GROWTH MANAGEMENT DEPARTMENT STAFF REPORT
VILANO BEACH TOWN CENTER OVERLAY DISTRICT

April 12, 2023 Public Meeting

VBTCDR 2023-01 Vilano Beach Townhomes (aka Breakwater Villas)

To: North Coastal Design Review Board
Staff: Sloane Stephens, Planner
Date: April 5, 2023

Conceptual Vilano Road Fountain

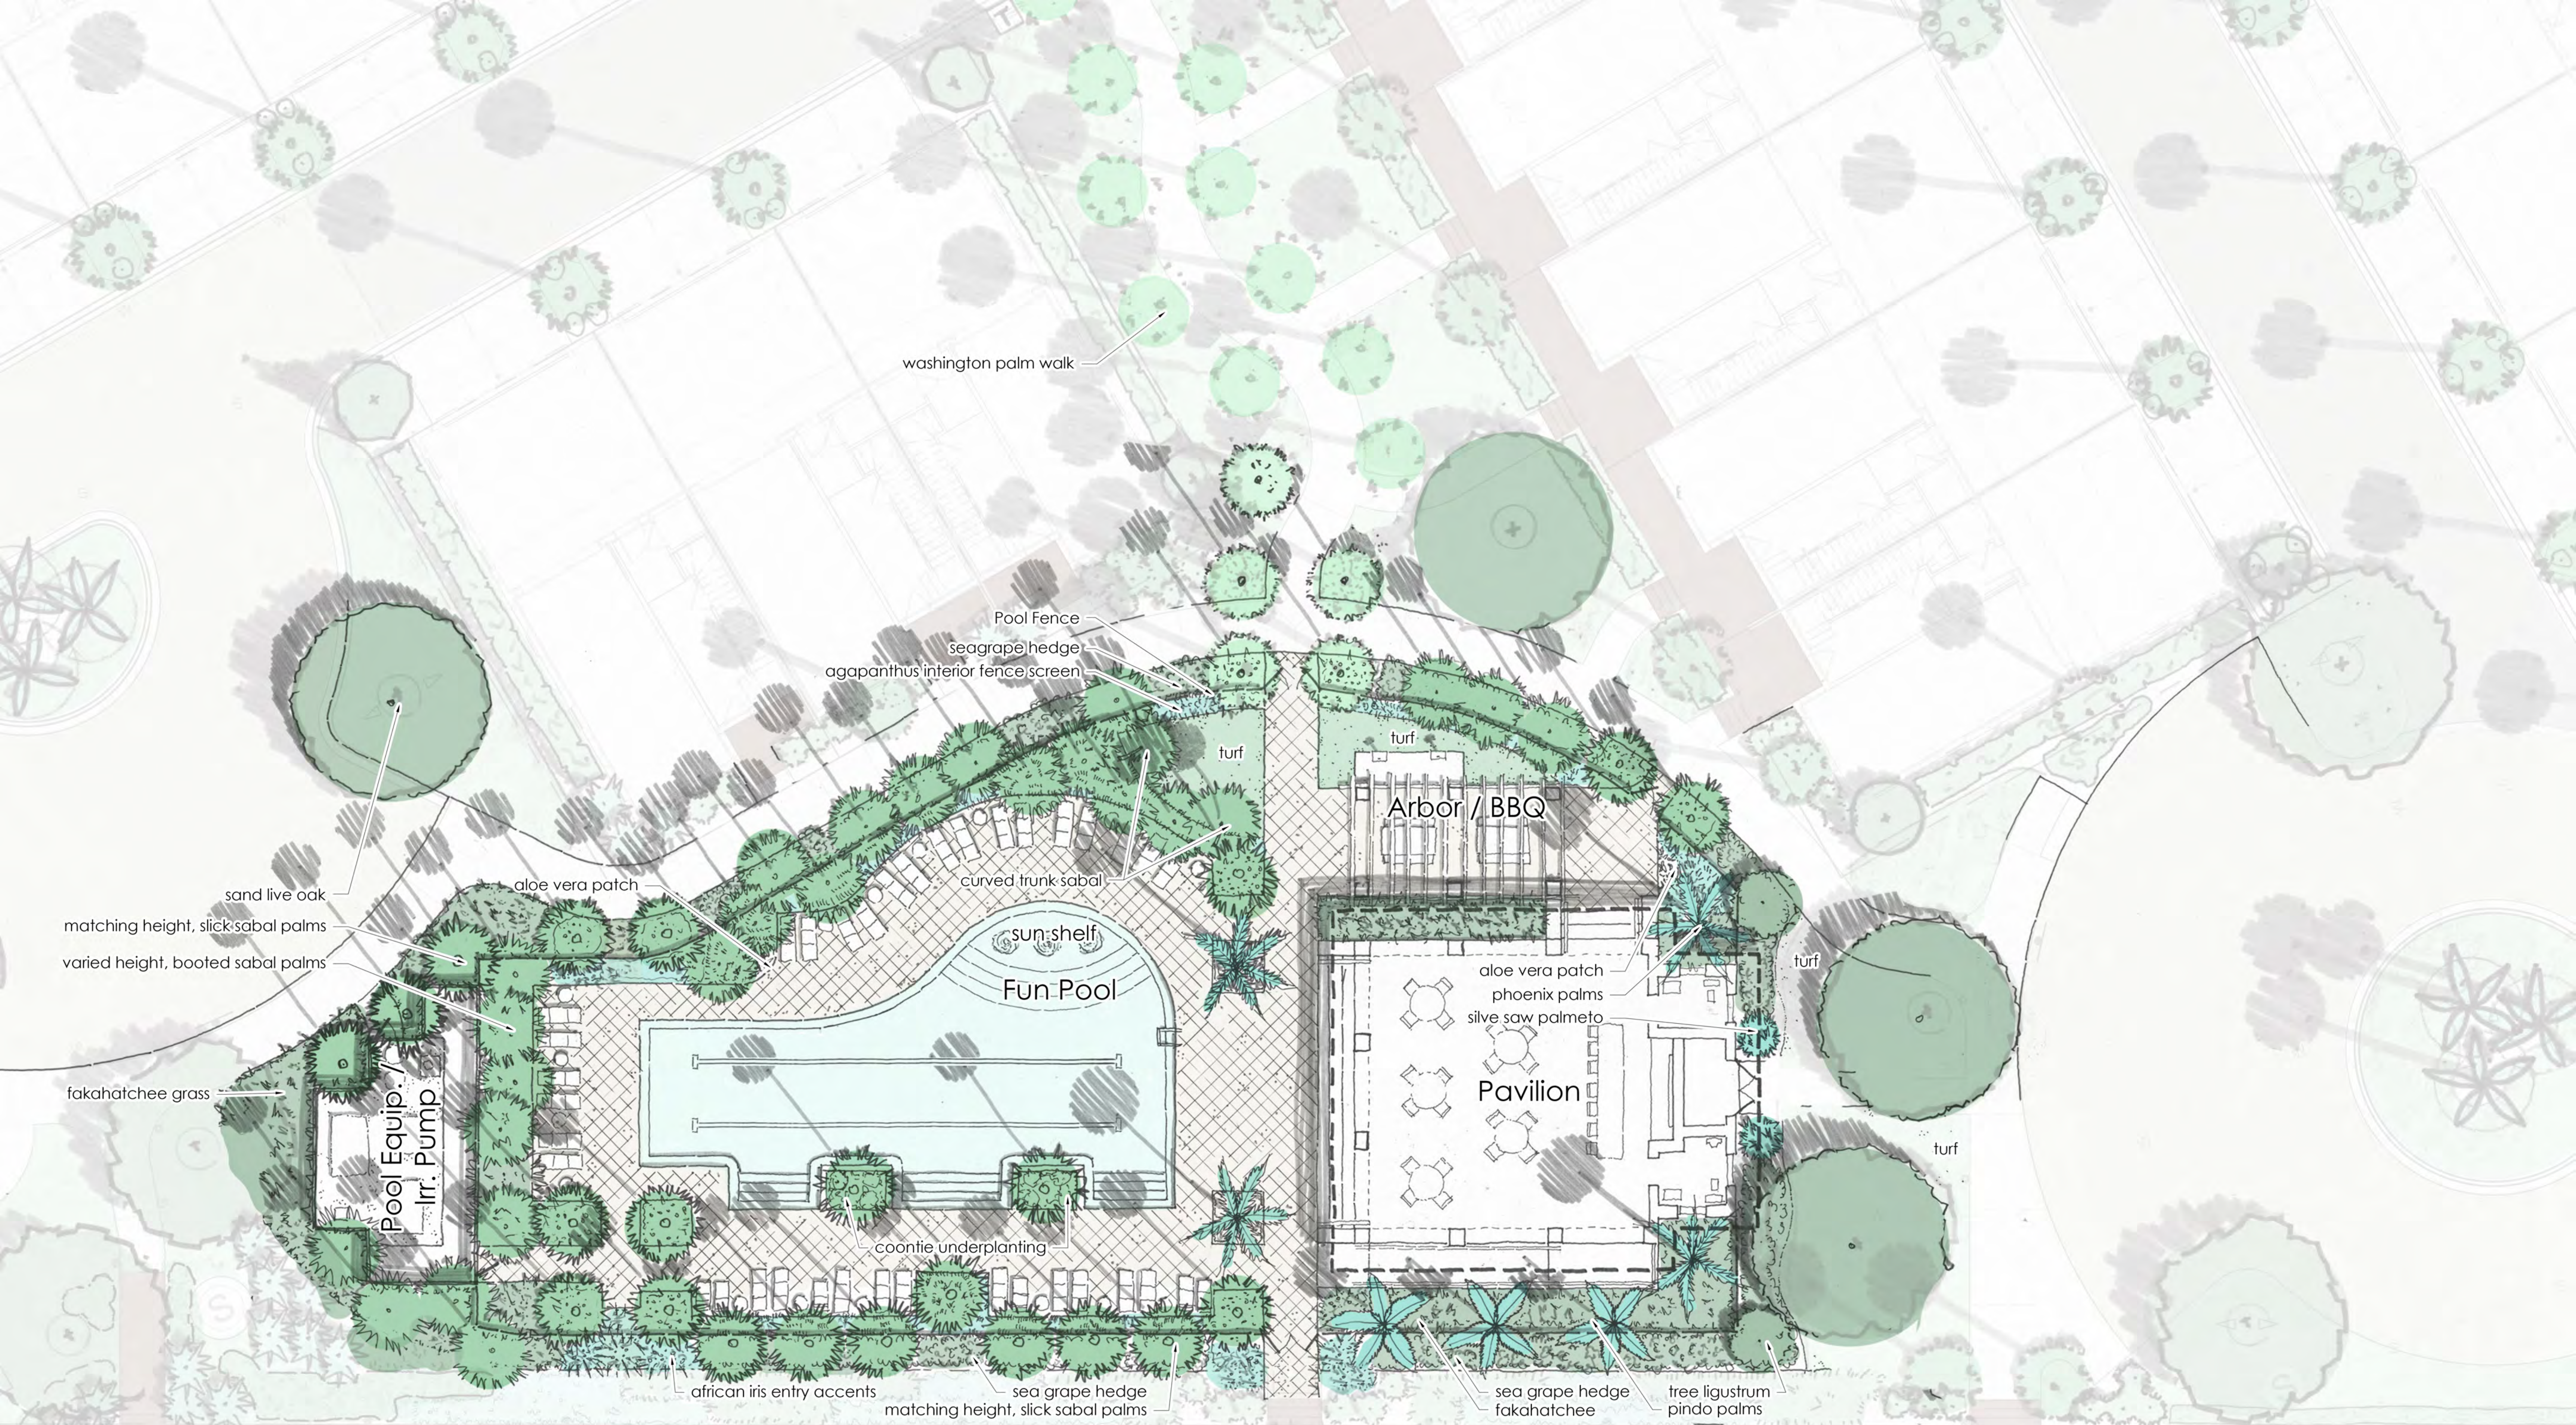
The proposed fountain is to replace a previously existing streetscape fountain. Per LDC Section 3.10.05.A.13, fountain elements are encouraged in the Vilano Town Center area to provide for bicycle and pedestrian activity. The proposed fountain appears to have the same mosaic tile pattern as the previous fountain, adds some optional seating for pedestrians, and will be visible from all sides of the walkway. Please see the below comparison of the previously existing versus the proposed fountain design:

Amenity Conceptual Site Plan

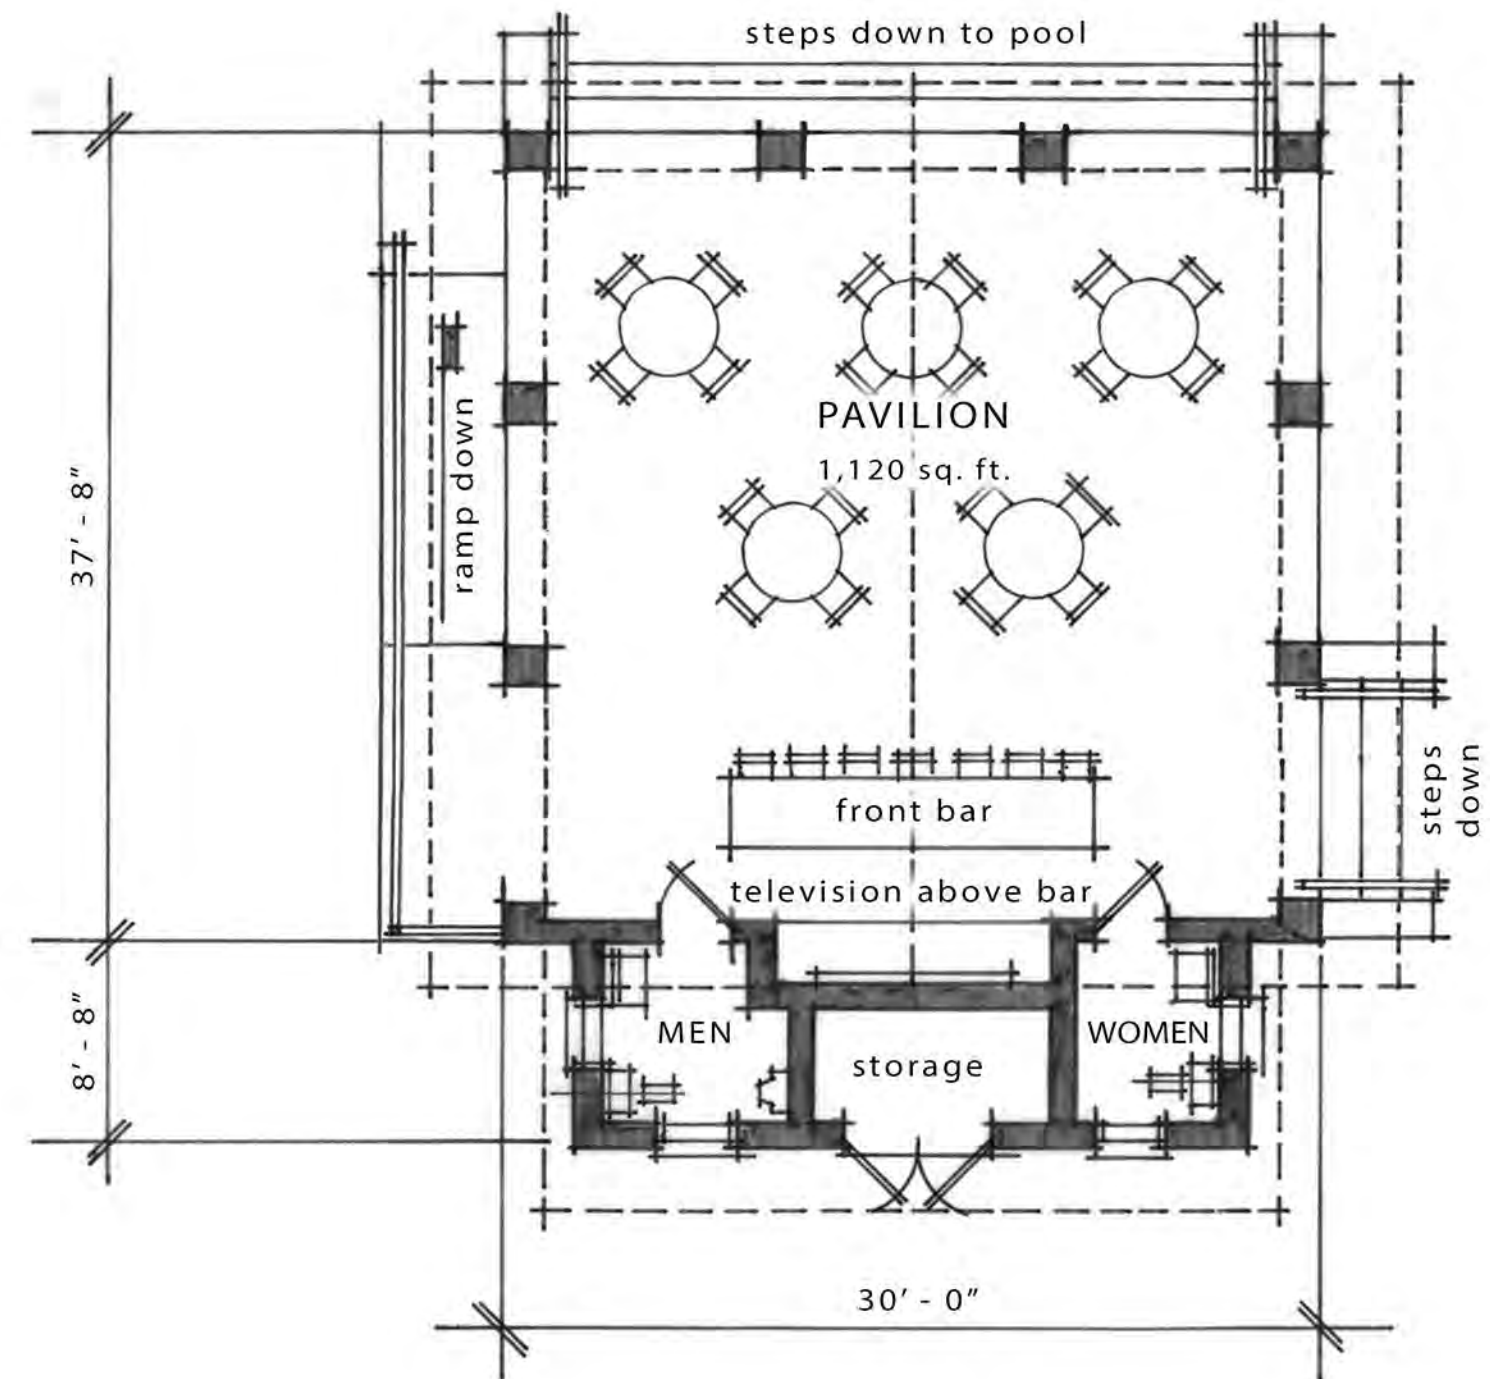
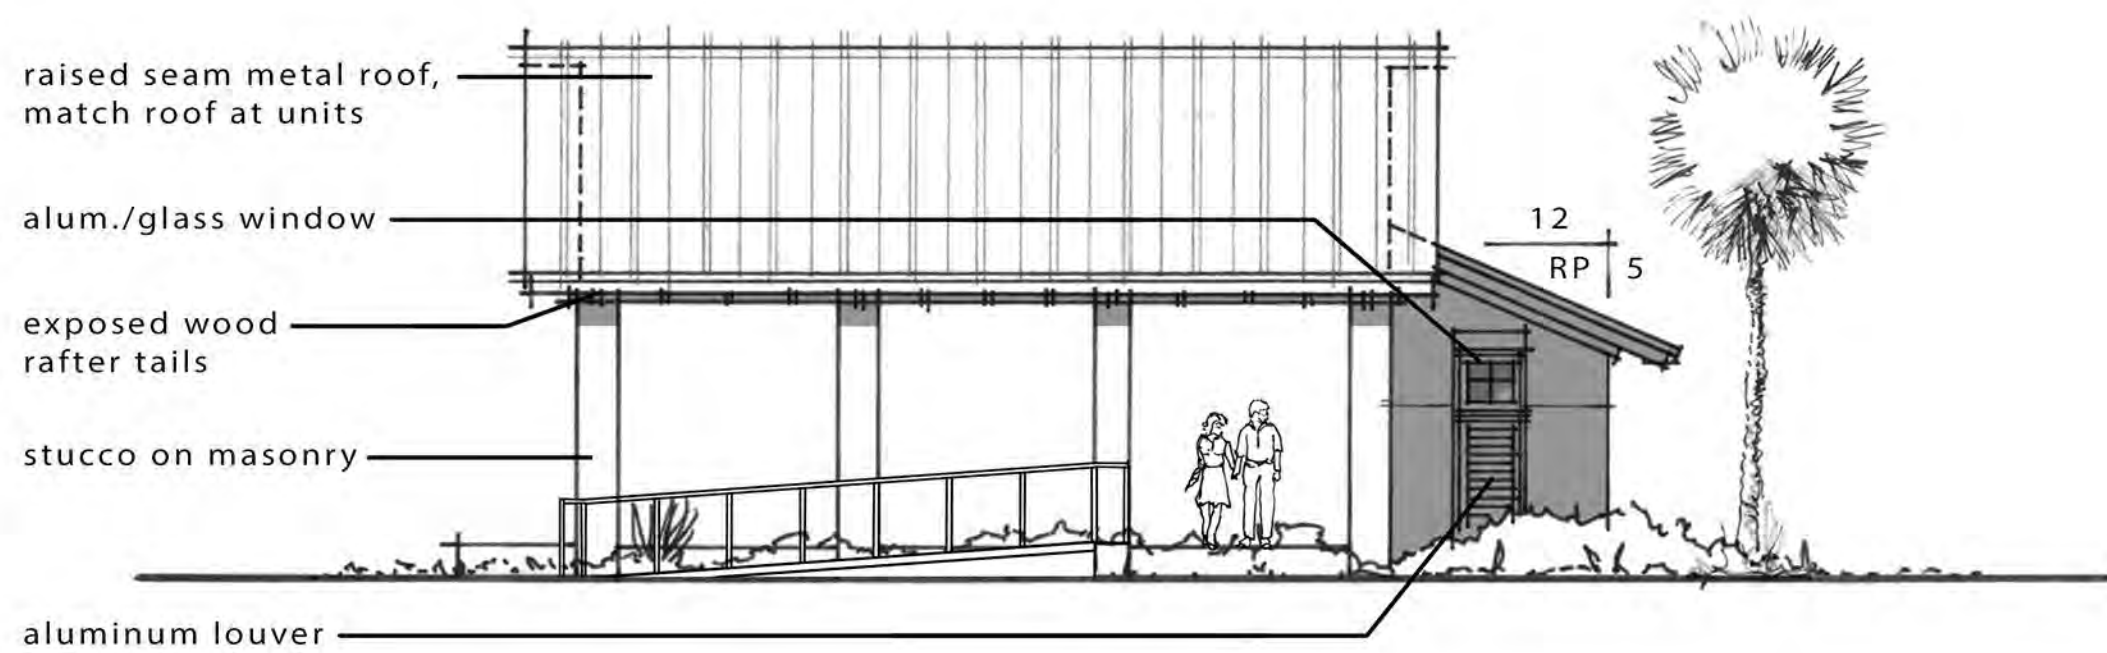
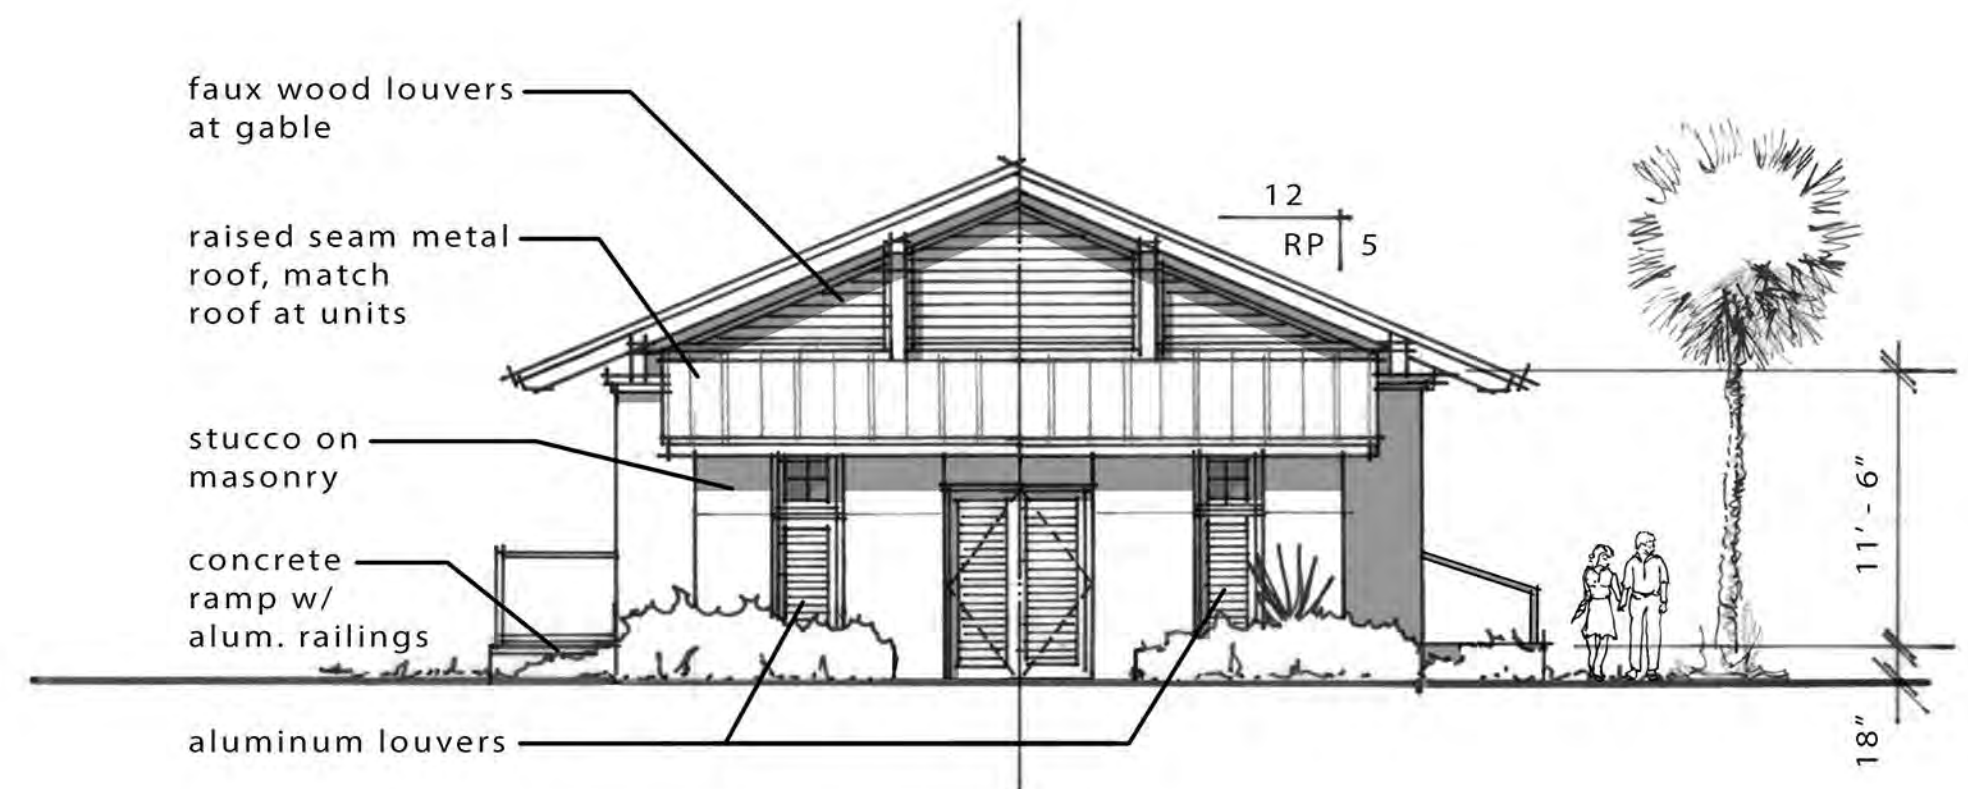
Although the conceptual pool pavilion elevations are not in color, it appears it is the Applicant's intention to have the architectural style match the townhome buildings' Florida Vernacular style. Upon review, this would be compliant with LDC Section 3.10.05.G. Staff has recommended that the Applicant prepare colored elevations of all sides of the conceptual pool pavilion for Board review. The Applicant has stated they will come prepared with those materials to the meeting on April 12th.
